HISTORIC AND DESIGN REVIEW COMMISSION

HDRC CASE NO: 2024-012
COMMON NAME: 622 SHERMAN
LEGAL DESCRIPTION: NCB 1300 BLK 1 LOT 9
ZONING: R-5 CD, H
CITY COUNCIL DIST.: 2
DISTRICT: Dignowity Hill Historic District
APPLICANT: Terry Richardson
OWNER: Terry Richardson
TYPE OF WORK: Construction of a 2-story, multi-family residential structure, construction of a detached accessory structure
APPLICATION RECEIVED: January 24, 2024
60-DAY REVIEW: February 16, 2024
CASE MANAGER: Edward Hall

REQUEST:

Historic and Design Review Commission
Design Review Committee Report

FRONT ELEVATION
SCALE 1/4" = 1'-0"

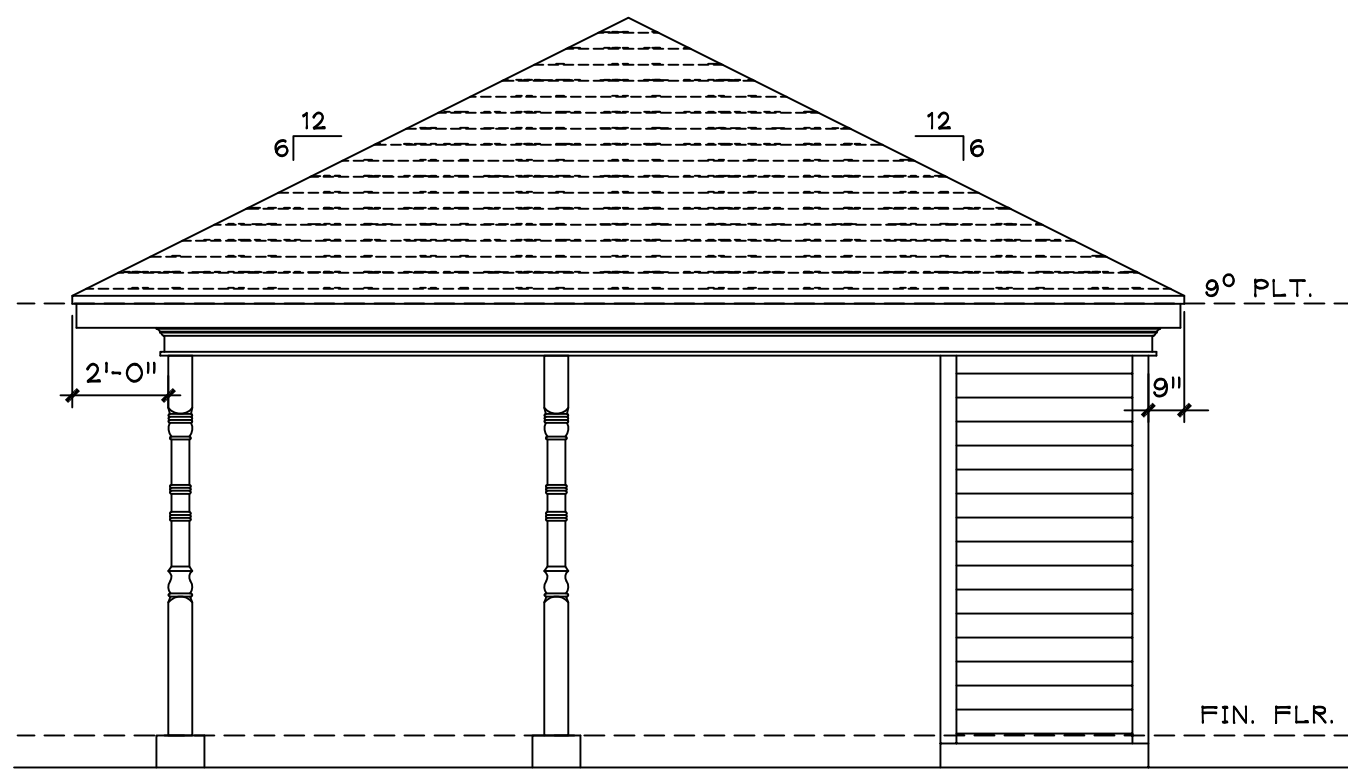
- h. ENTRANCES – The applicant has submitted a front elevation showing two, front facing entrance doors. Staff finds the proposed front facing entrances to be appropriate as there are historic examples throughout the historic district where historic structures feature two, front facing entrance doors.

- o. FENESTRATION PROFILE – The applicant has proposed a fenestration profile that is generally consistent with the Guidelines for New Construction. The applicant has proposed two window profile options; one over one and four over four. Staff finds both profiles to be appropriate.

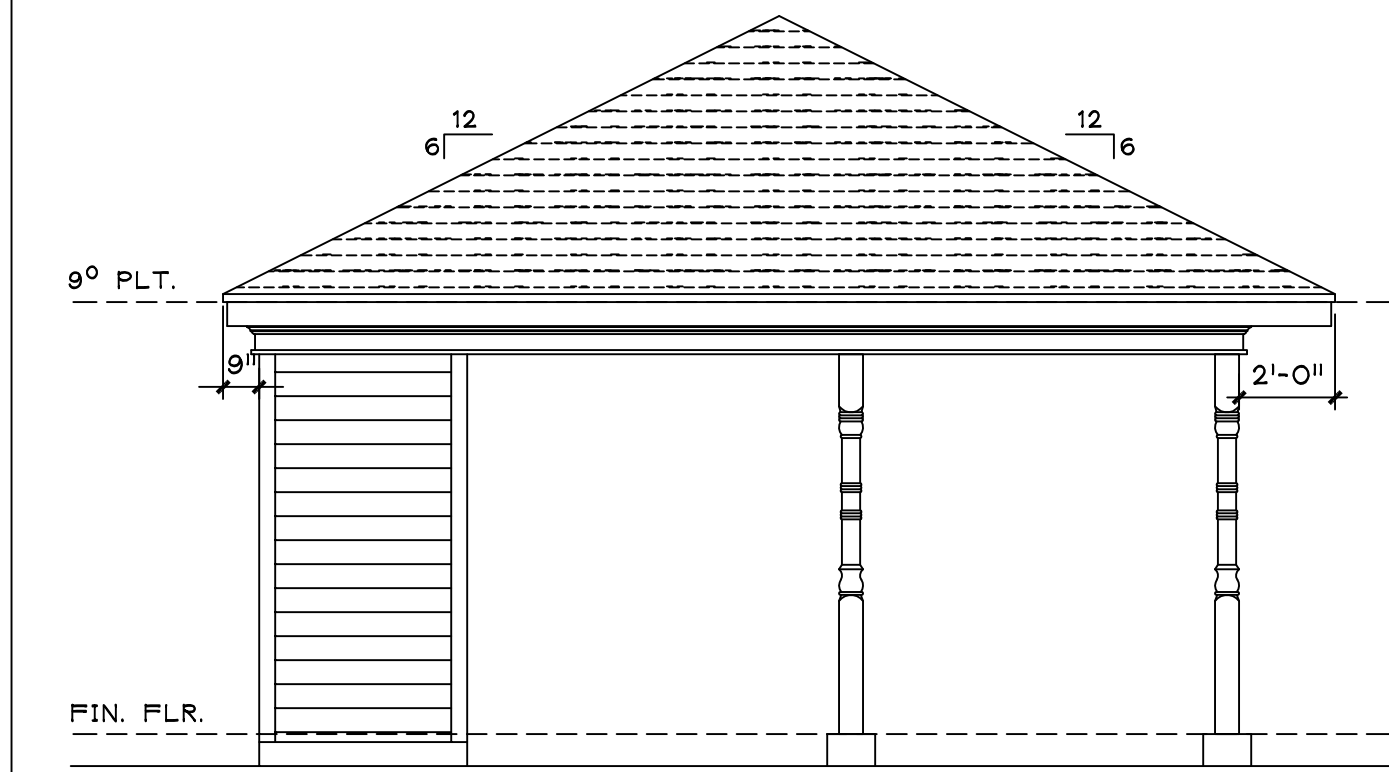
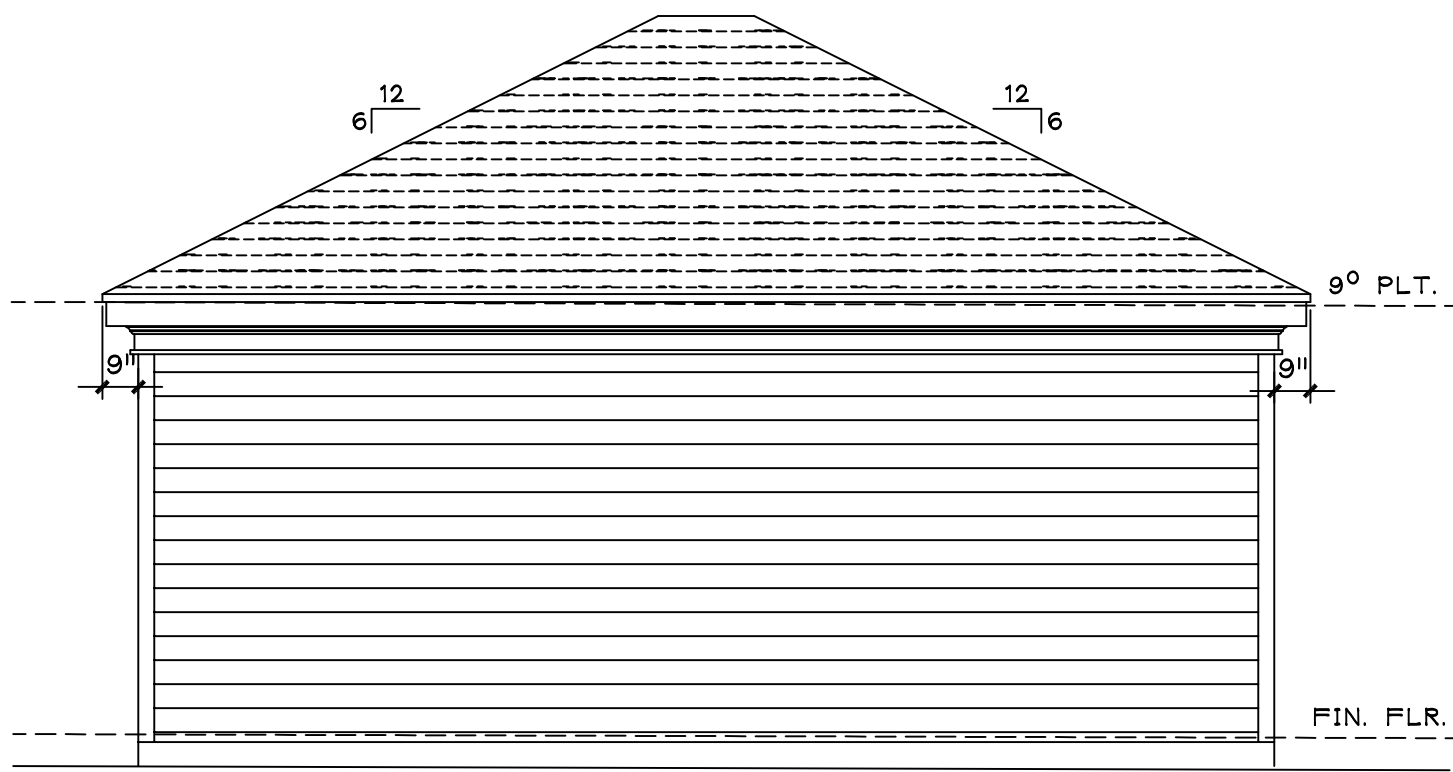
JF: Explore fenestration on east and west facades. TR: Can add windows on first and second levels at this location.

SITE PLAN

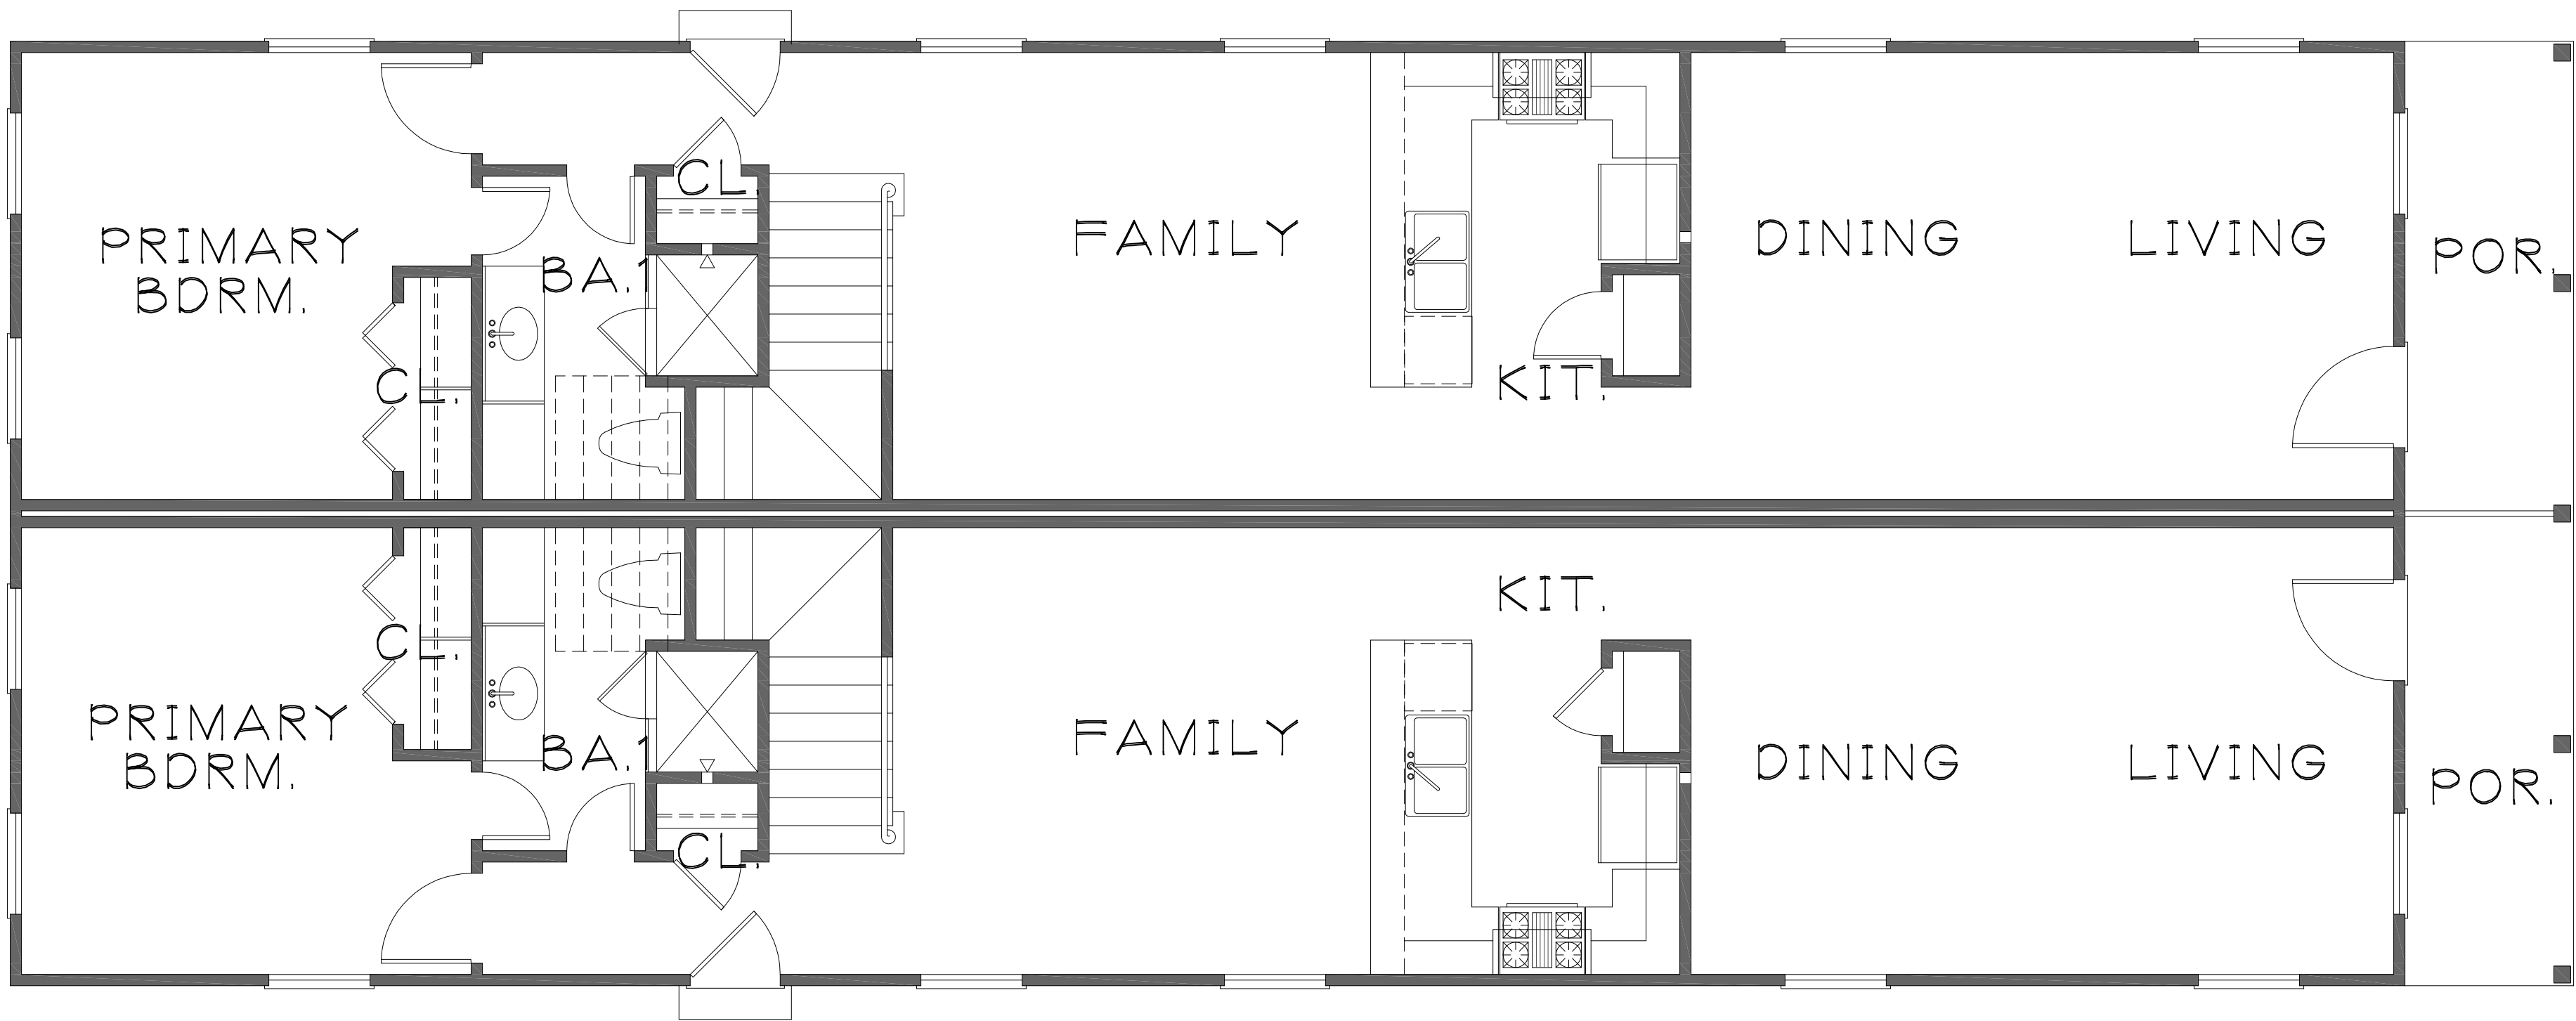
- l. LOT COVERAGE – The applicant has noted a total lot coverage of 46.35 percent. The applicant has included paving, the primary structure and the rear accessory structure in the lot coverage calculation. The Guidelines for New Construction 2.D.i. notes that new construction should be consistent with adjacent historic buildings in terms of the building to lot ratio. Footprints of new construction should be limited to no more than fifty (50) percent of the total lot area, unless adjacent historic buildings establish a precedent with a greater building to lot ratio. Staff finds the proposed lot coverage to be appropriate and consistent with the Guidelines.

- s. DRIVEWAY – The applicant has proposed for the site to feature one (1) driveway to feature nine (9) feet in width and a ribbon strip profile. There is one existing curb cut and approach on site. The Guidelines for Site Elements 5.B.i notes that similar driveway configurations, regarding materials, width and design, should be used when installing new driveways. The predominant and historic driveway configuration on Sherman Street and throughout the Dignowity Hill Historic District is one driveway, per lot. Staff finds the proposed driveway to be appropriate.

- u. MECHANICAL EQUIPMENT – All mechanical equipment should be installed in a manner where it is screened from view from the right of way.
- v. REAR ACCESSORY/PARKING – The applicant has noted parking at the rear of the lot with a rear accessory structure to provide covered parking for two automobiles. Generally, staff finds the massing, profile and architectural elements of the accessory structure to be appropriate. Additionally, staff finds the proposed crushed granite parking location and rear yard paving to be appropriate.
